## Service Bulletin SB-14

December 8, 2025

This Mandatory Service Bulletin addresses the use of the MC0743624-2 Shimmy Dampener Assembly on various Cessna 210 model aircraft. An interference issue has been identified between this shimmy dampener and the nose gear door and nose gear door linkage.

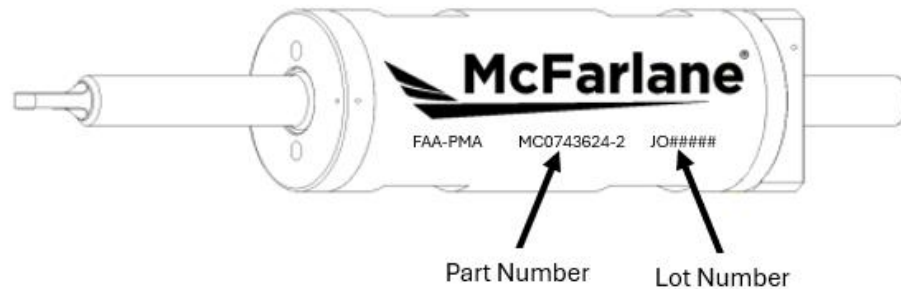
The Part Number and Lot Number for the shimmy dampener assembly can be identified on the barrel of the assembly as shown:

- Remove the MC0743624-2 shimmy dampener assembly from affected aircraft per the applicable Cessna/Textron Model Service Manual.
- Return assembly to McFarlane Aviation, LLC.
